CITY OF West Linn

Memorandum

Subject: Additional Public Comments Received for DR-23-01

To West Linn Historic Review Board
From Ian Brown (1968 6th Ave)
Audra Brown (1968 6th Ave)
Re DR 23-01 (1919/1949 Willamette Falls Drive), 11/14/23 meeting

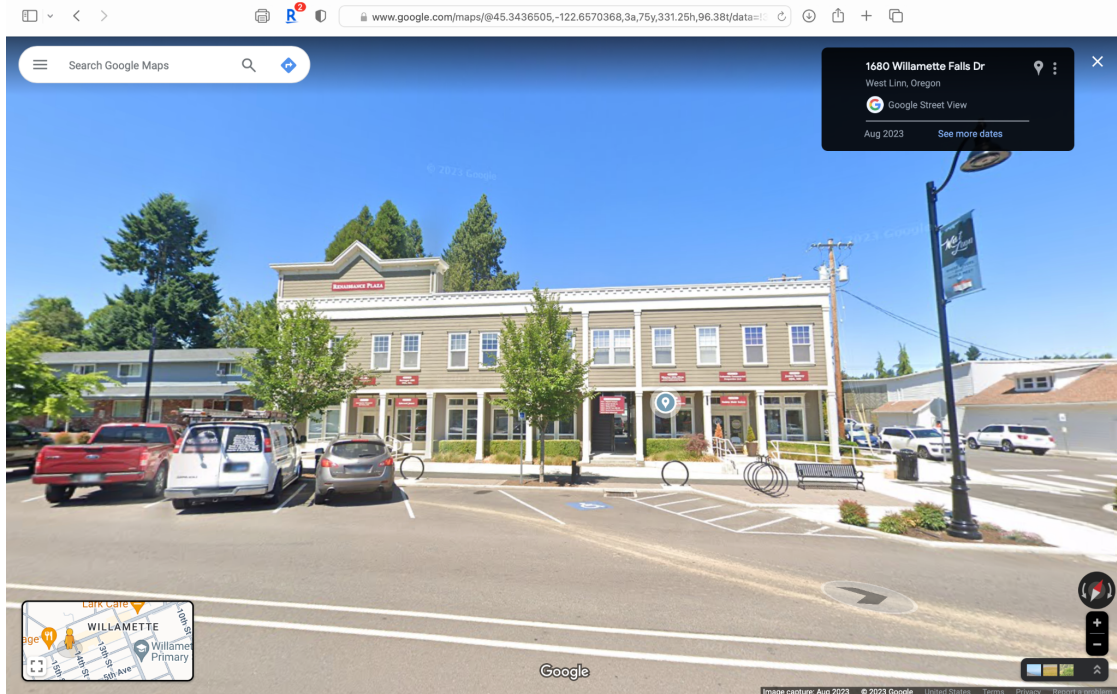
1849 Willamette Falls Drive is a modest example of an older local building with third-story space hidden behind a western false front.⁵ The third-story space is in a conventional “half-story” configuration, making use of the space under a gable roof. The false front has the appearance of a tall parapet rising from the second story. It has the same lap siding material, painted in the same color scheme, as the first and second story. It has no windows. It runs only along the side of the building that faces Willamette Falls Drive and joins no right angles. It steps down as the distance from the gable ridge line increases and plainly could not be the wall of a full third story. Because the false front faces only the street side of the building, a person viewing it at an angle off of center can easily see empty space behind it, creating the impression that there is no third story structure at all. The overall effect is to render the third story structure very difficult to identify from Willamette Falls Drive, 12th Street, or 13th Street.

The applicant's third-story structure is completely different. Rather than a street-facing false front that steps down with distance from a ridgeline, it has four straight walls joined by at right angles, creating the visually unambiguous appearance of a 25' by 100' box. Rather than using a half-story configuration with a sloping roof to minimize visibility, it has a flat roof to maximize space. Rather than being set back from the streets on the sides to minimize visibility, it is set at the edge of the second story on all three sides that are visible to the public. Rather than eliminating windows altogether from the street-facing side, it displays large sets of windows on the most prominent corner of the building, windows that clearly correspond to the second-story windows below. Unlike the third-story structure of 1849 Willamette Falls Drive, which is well-hidden from three sides, the applicant's third-story structure is impossible to miss from the north, west, or south.

The comparison with 1849 Willamette Falls Drive does not support the application of criterion A. Rather, it shows that the applicant's proposal is not correct for the period architecture in the area.

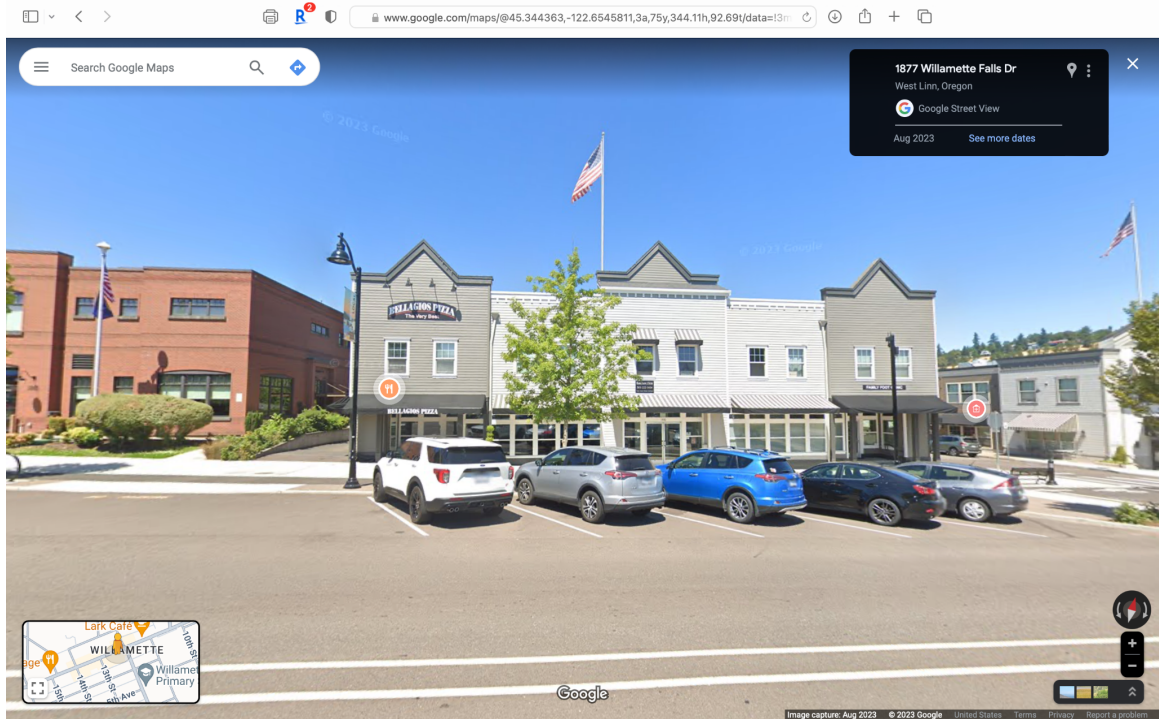
The applicant's proposal has a box-shaped configuration set on three edges of the building. It has prominent vertical walls on all sides and a grand set of windows anchoring the most prominent corner. It is not comparable to the configuration of 1672 Willamette Falls Drive, which has a false front with no windows hiding a gabled half-story set far from the side streets.

It is incompatible with the rationale for the exception granted for 1672 Willamette Falls Drive, which was based on the third-story structure being difficult to see. Based on this example, even assuming that the Historic Review Board would grant the same exception if given the chance, it is difficult to imagine the same Historic Review Board approving an exception for the present application.

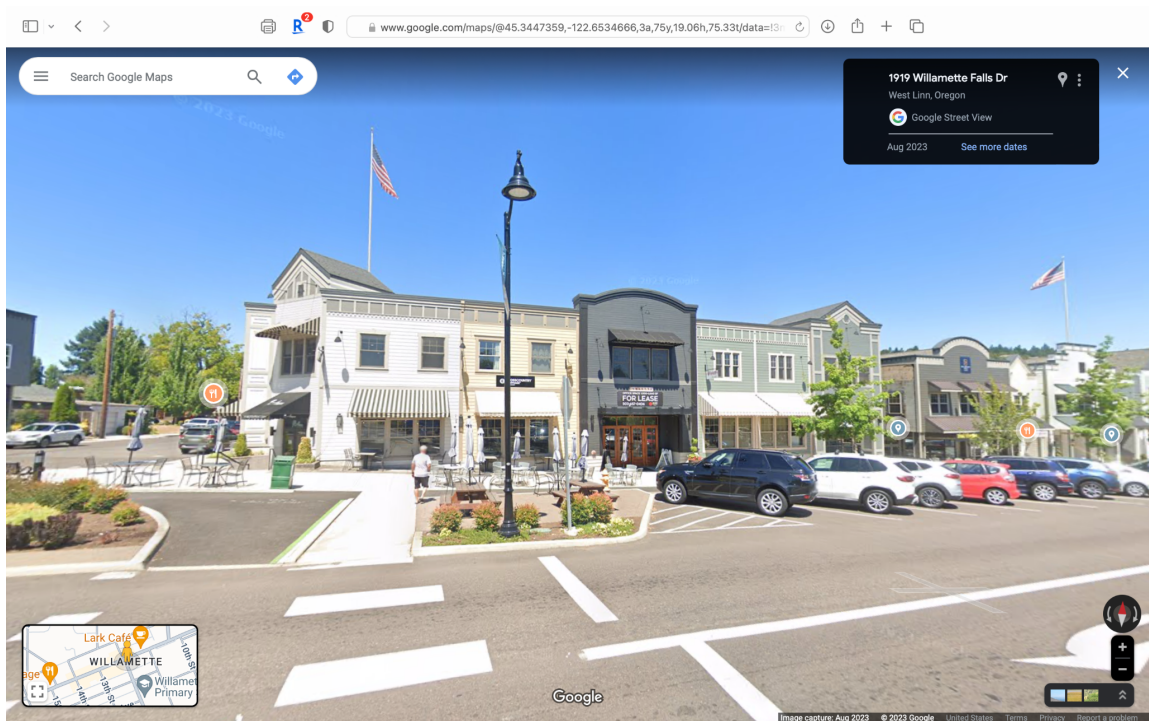
The design of 1914 Willamette Falls Drive, another recent building located at the same intersection as 1880 Willamette Falls Drive and the applicant’s proposal, shows attempts at a similar effect. The rooftop structures are small, with gable roofs, and they have the appearance of mechanical screening. There is no appearance of usable third-story space. The design review process (DR-06-46) shows that even the appearance of a third story was to be avoided. The pre-application conference resulted in the elimination of “third floor” windows, and the Historic Review Board then required the elimination of “the circles/cutouts at the top of the false gable end.”

Again, the applicant's proposal, with a prominent third story, would stand in stark contrast to 1914 Willamette Falls Drive, which was built to avoid any features suggestive of a third story.

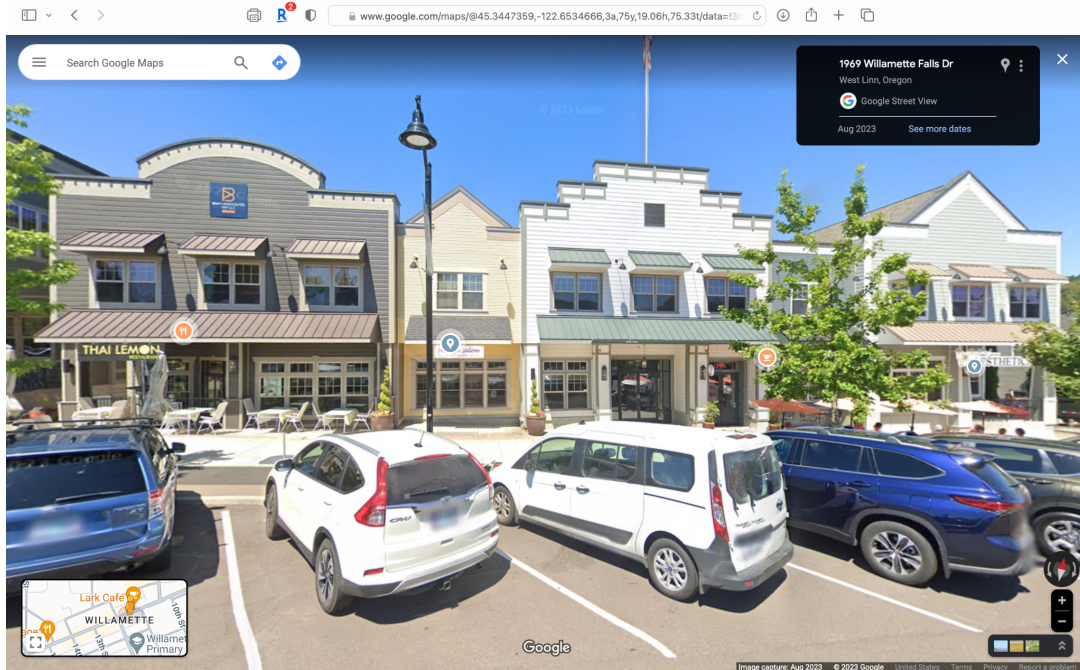
1980 Willamette Falls Drive, another relatively recent building on the same block as 1914 Willamette Falls Drive, also has the appearance of a two-story building with some structure to house rooftop mechanical equipment. The Historic Review Board (DR-01-43) required any HVAC on the roof to be visually screened on all sides. It also required two of the three vents, which were cut into the western false fronts, to be eliminated. As a comparison of the overhead and front views shows, the remaining vent is on the false front that is in the middle of the building, not attached to a rooftop structure. There was no exception granted for a third story. As with the other very new buildings, it has rooftop structures that have gable roofs, are screened from the street by western false fronts, and have no windows to suggest the presence of a third story.

Again, the applicant’s proposal would be an obvious three-story building sitting across the street from 1980 Willamette Falls Drive, a two-story building designed to eliminate the hint of a third story.
